ZONING CHANGE REVIEW SHEETCASE: C814-2020-0104DISTRICT: 3ZONING FROM: GR-MU-CO-NP and RR-NP TO: PUD-NPADDRESS: 1011 and 1017 Springdale RoadSITE AREA: 30.18 acresPROPERTY OWNER:

Springdale Green PUD

C814-2020-0104

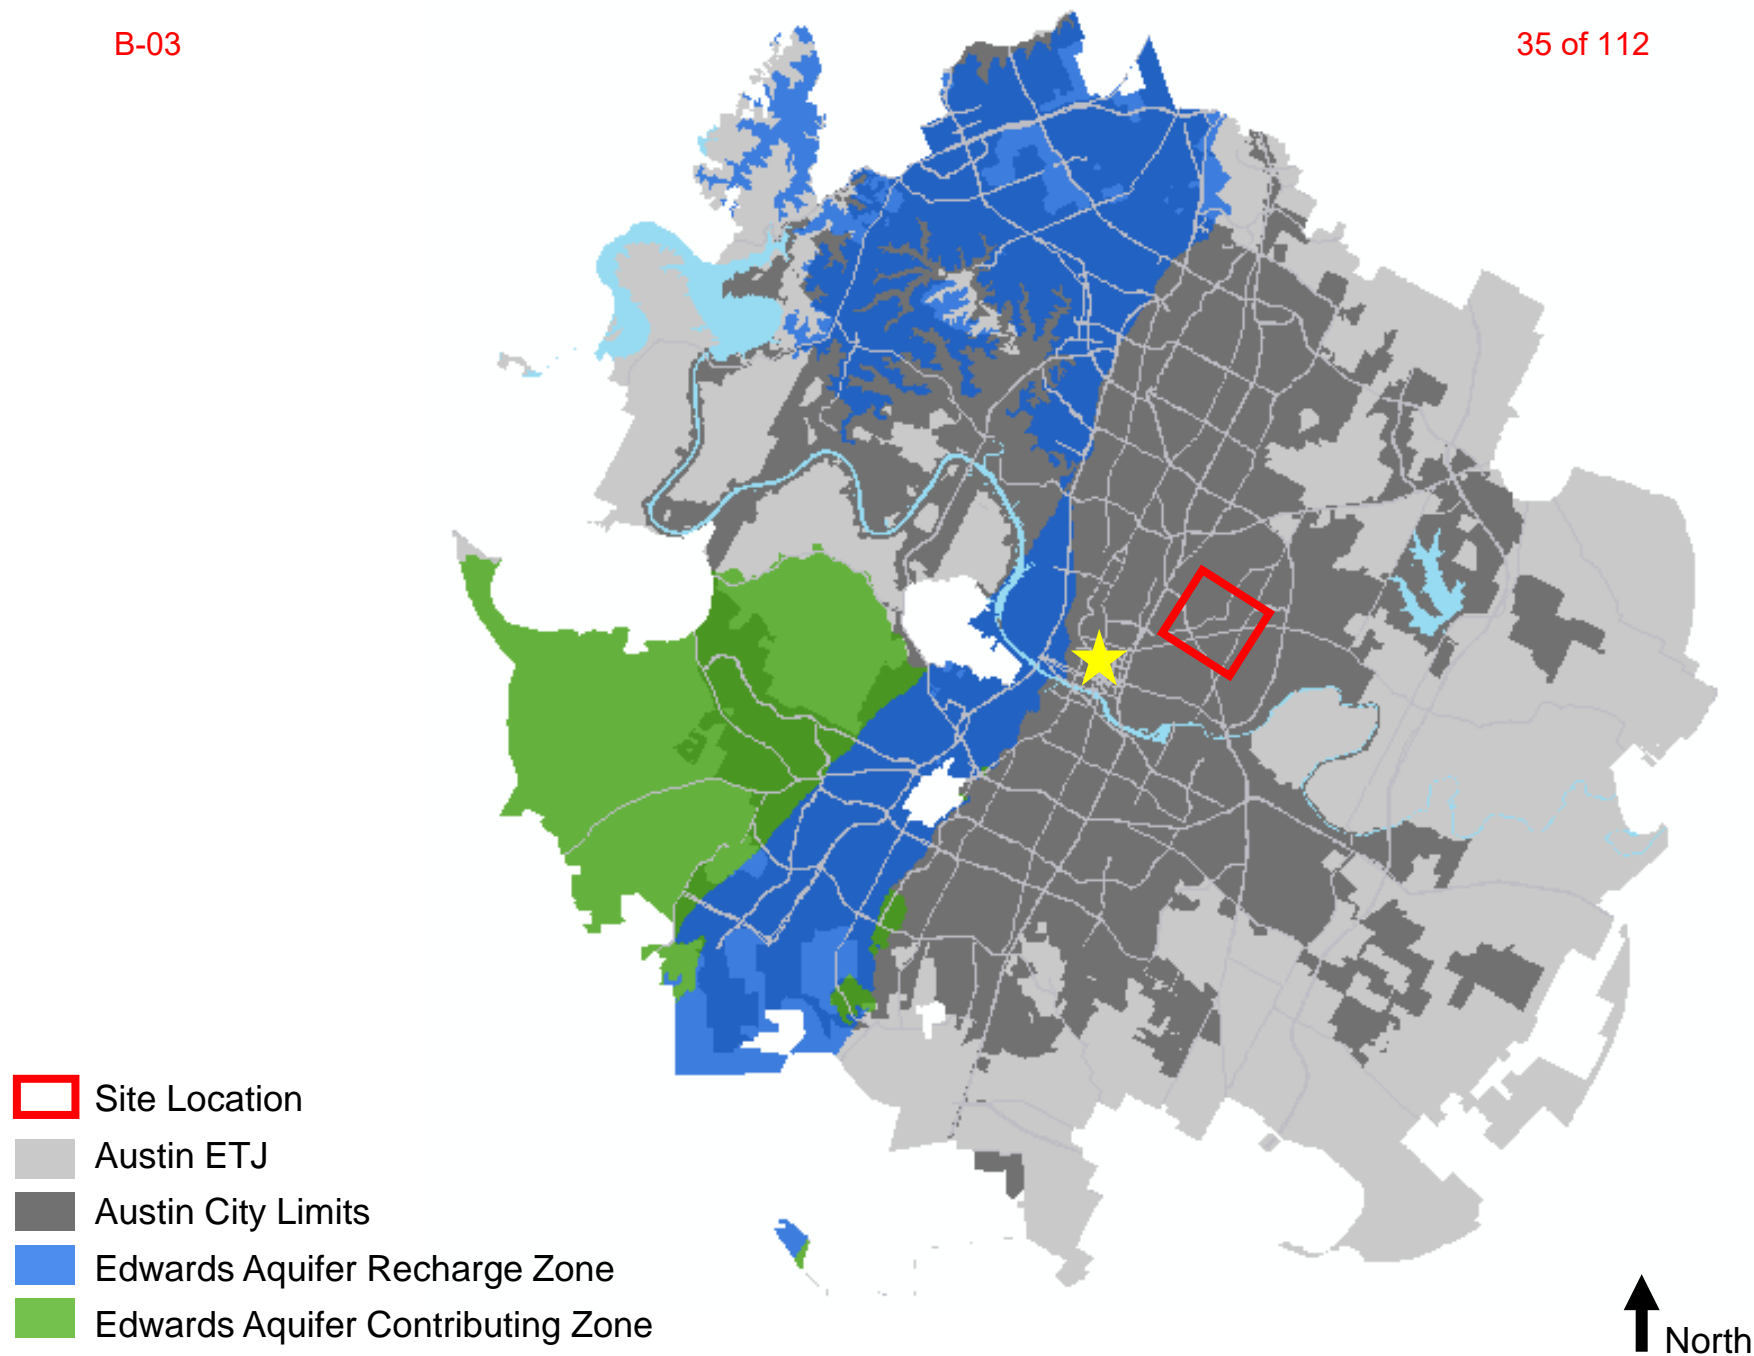
1. Street yard trees will be a minimum of 2 caliper inches.
2. Street yard landscape area shall be increased to a minimum of 30% of street yard area.
3. Code required tree mitigation will be increased by 50%.
4. A minimum will be 15 trees will utilize silva cell technology.
5. 15 acres of creek and floodplain will be restored per exhibits.
6. 100% Green Stormwater Infrastructure for water quality.
7. Modify watershed boundaries to redirect flow of storm water away from the single-family homes located on Saucedo Street.
8. Cap impervious cover at 50% gross site area.
9. Provide 20.71 acres of Open Space.

10. Remove existing impervious cover from the critical water quality zone and restore with native vegetation.
11. Capture rainwater and condensate to reduce landscape water usage by 50%.
12. Meet 3-Star green building rating for all buildings on-site.

Critical Water
Quality Zone

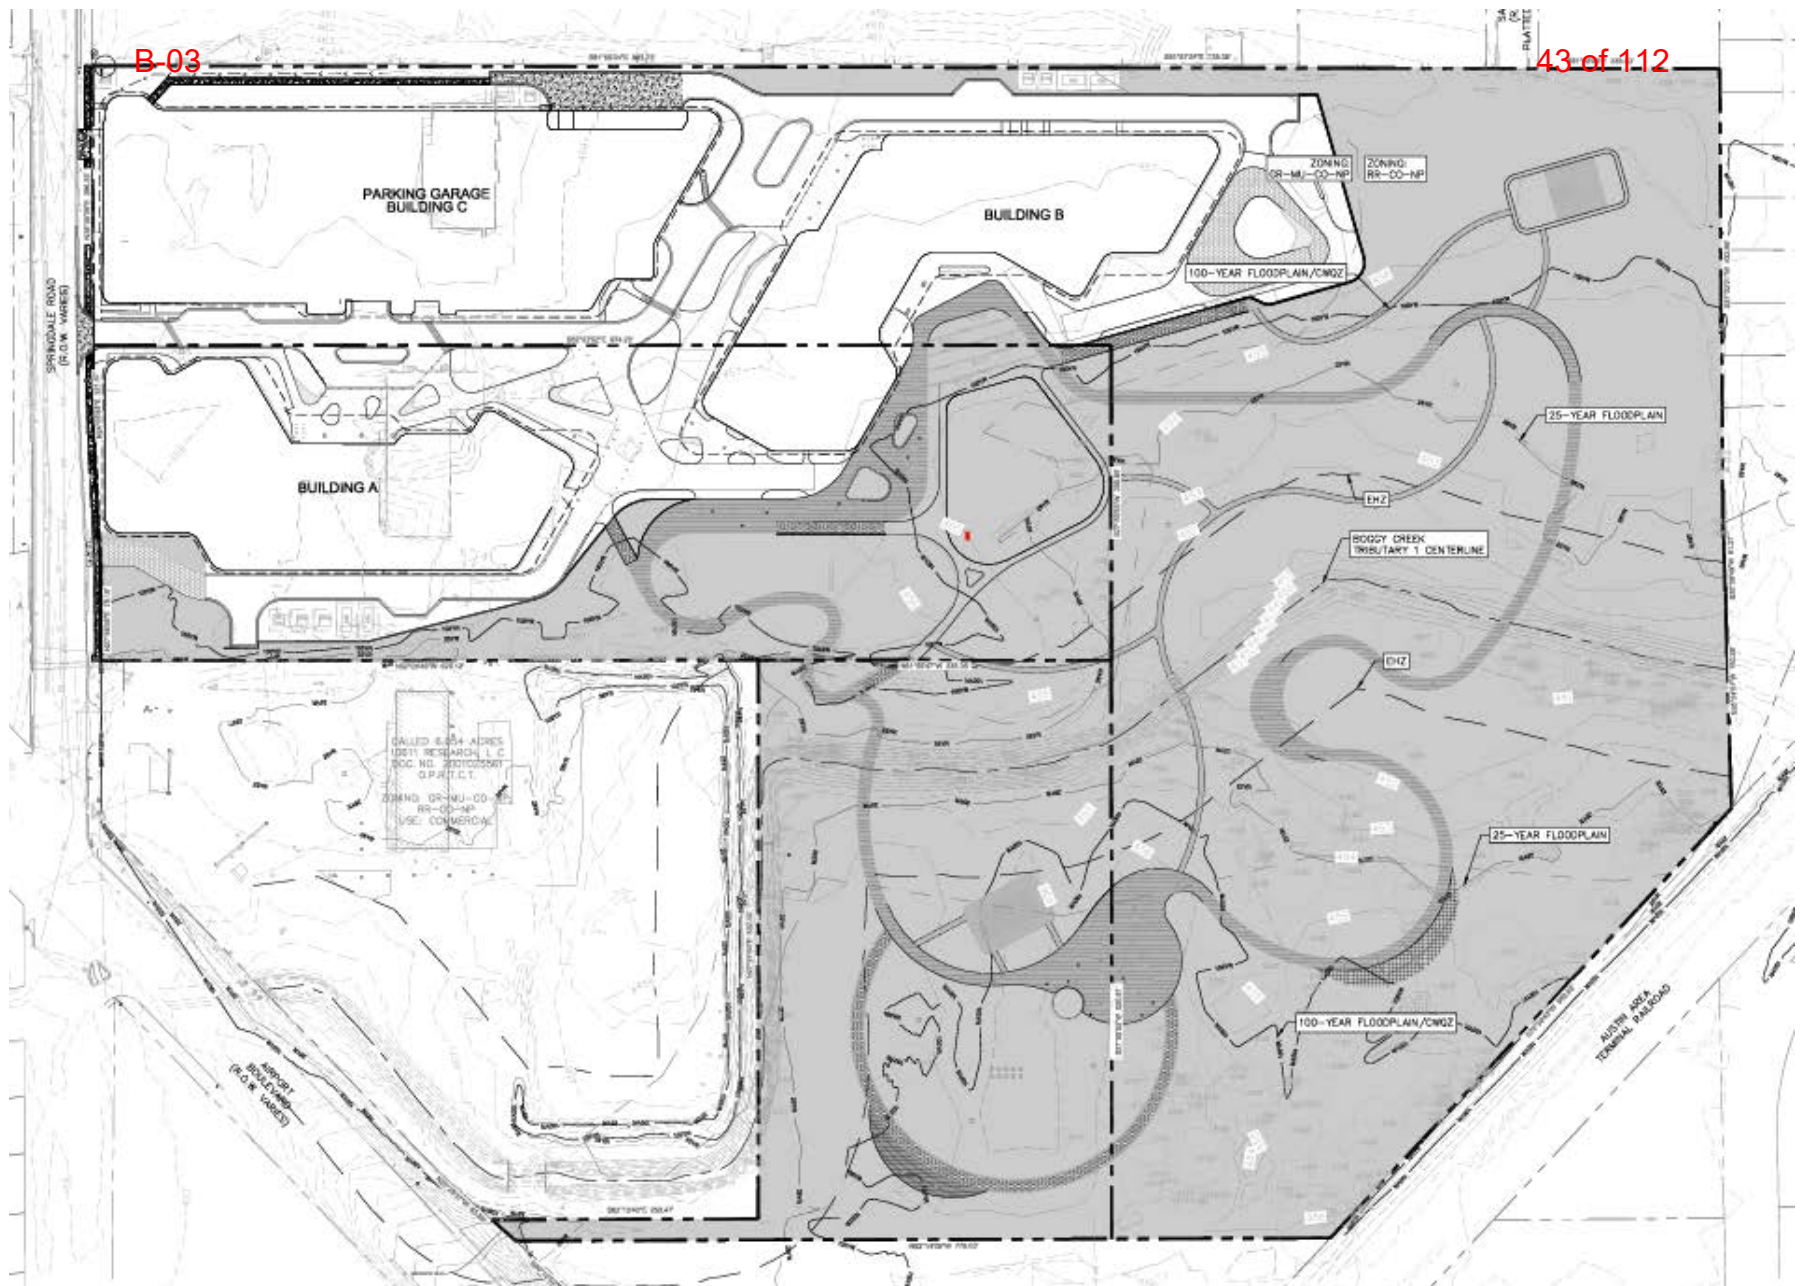
Existing Code	Proposed PUD	
Critical Water Quality Zone	Trails within the buffer are limited to 12'	Trails within the CWQZ will be wider in some places and should match the Open Space exhibit.	
Critical Water Quality Zone	Staging within the CWQZ buffer	Temporary staging will be allowed within the CWQZ during construction in the areas designated on the plan. After construction, the site will be de-compacted and restored per the restoration plan.	
Landscape Irrigation	Potable water	Capture rainwater and condensate to reduce water usage by 50%	✓
Landscape	Current code	<ul style="list-style-type: none">-Will provide silva cells for a minimum of 15 trees-Street yard trees increased by ½" caliper-Will provide trees and vegetation for 30% of street yard	✓
Dark Sky Initiative	Full cut-off or shielded per Subchapter E	Full cut-off or shielded per Subchapter E	
Green Building	2-Star Certified	3-Star Certified	✓

1. 25-8-261(B)(3)(C) is modified to allow a trail wider than 12 feet as shown on the Creek Plan.
2. 25-8-261 is modified to allow temporary construction staging within the CWQZ buffer per the Construction Laydown and Staging Limits exhibit.

Open Space Plan

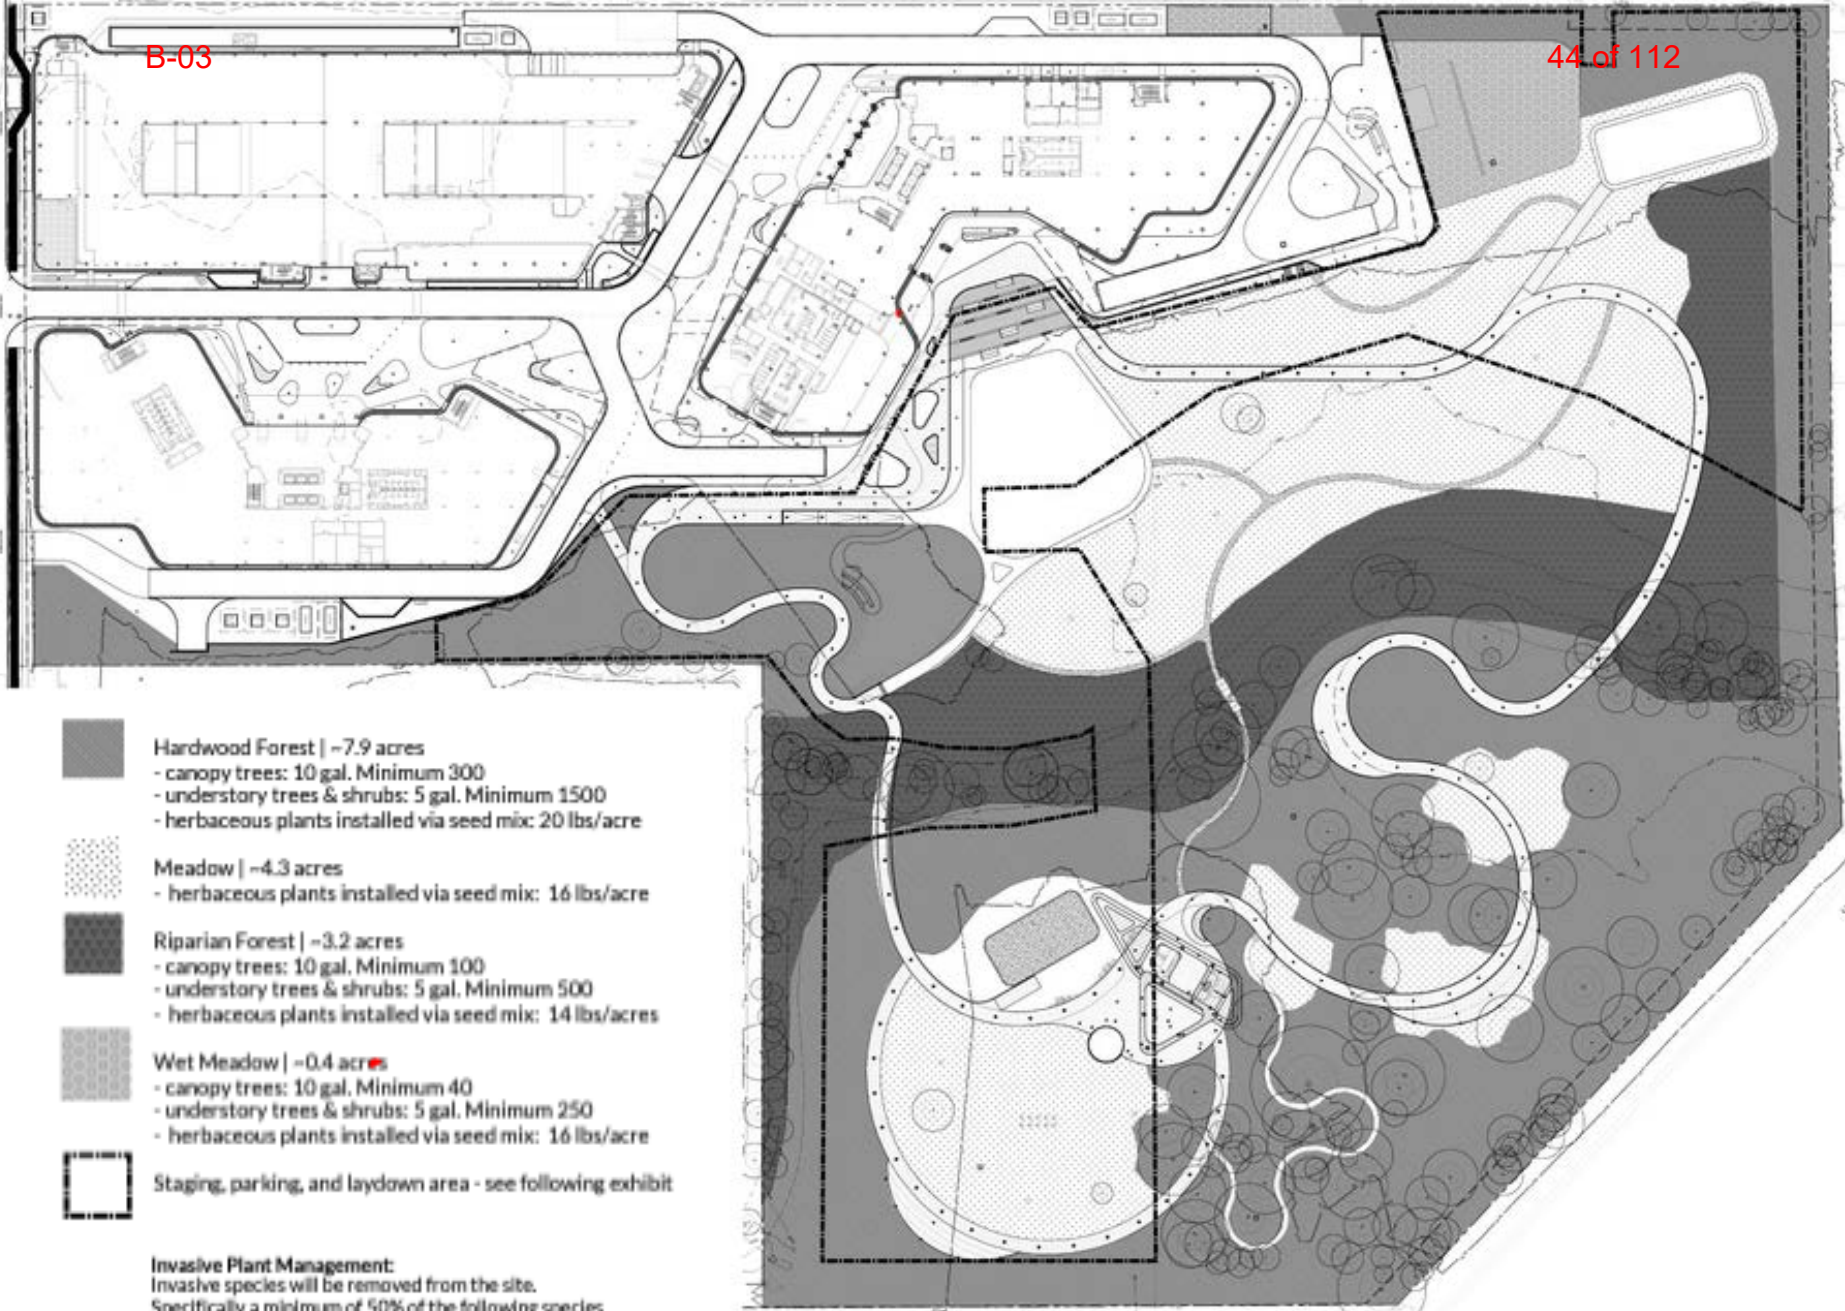
Required Open Space: 6.04 acres
 Provided: 19.82 acres
